Access Compliance Report

Public Rights-of-Way

(Curb Ramps)

Intersection ID: 47441	Main Street: POWATAN_CT	Cross Street: KALISPELL_LN	Location: SE
ADA ID: 64F01C96538A	Ramp Type: Perpendicular Diagonal	Initial Pass/Fail: Pass	Overall Compliance: No
Severity Score: 0.25			
Codes/Mitigation Info/Possible Solution		Field Measurements/Component Compliance

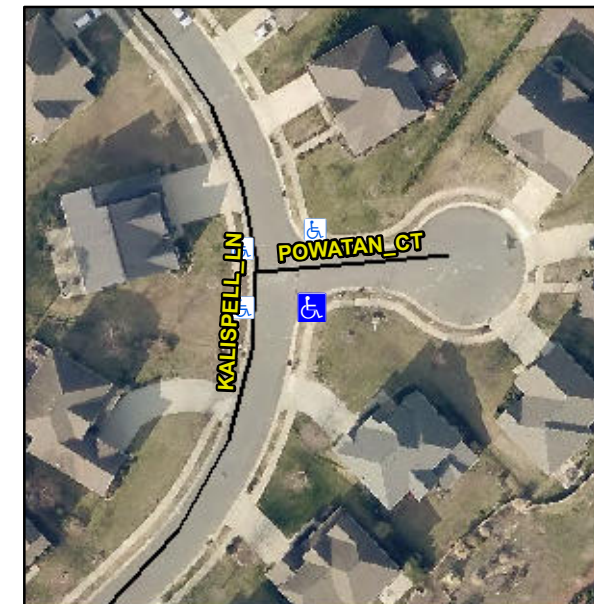
Not Found, R304.5.3, R304.2.2-Perp, R304.3.2-Para, R305.2

Compliance	Description	Data	Compliance	Description	Data
N/A	Ramp Length (in)	48.0	Yes	Ramp Slope (%)	6.5
Yes	Ramp Width (in)	48.0	No	Ramp XSlope (%)	4.8
N/A	Flare Type LT	Sloped	N/A	Flare Type RT	N/A
N/A	Flare Slope LT (%)	5.4	Yes	Flare Slope RT (%)	0.9
N/A	Flare Traversable LT?	Yes	N/A	Flare Traversable RT?	Yes
Yes	Landing Length (in)	48.0	Yes	DWS Provided?	Yes
Yes	Landing Width (in)	48.0	Yes	DWS Contrast?	Yes
No	Landing Slope (%)	2.3	Yes	DWS Length (in)	24.0
No	Landing X Slope (%)	5.1	Yes	DWS Full Width?	Yes
N/A	Landing Curb? (Y/N)	No	No	DWS Offset (in)	10.0
N/A	Shared Landing?	No			
Yes	Gutter Ponding?	No	Yes	Gutter Slope (%)	1.3
Yes	Gutter Lip Ht (in)	0.0	No	Gutter X Slope (%)	3.9
N/A	Painted X Walk1?	No	N/A	Painted X Walk2?	No
	X Walk 1 Direction	To N		X Walk 2 Direction	To W
N/A	X Walk 1 Width (in)	N/A	N/A	X Walk 2 Width (in)	N/A
	X Walk 1 Slope (%)	0.4		X Walk 2 Slope (%)	0.2
	X Walk 1 X Slope (%)	1.0		X Walk 2 X Slope (%)	2.1

Remove & Replace Curb Ramp With Two New Directional Ramps or Equivalent. Remove & Replace Gutter.
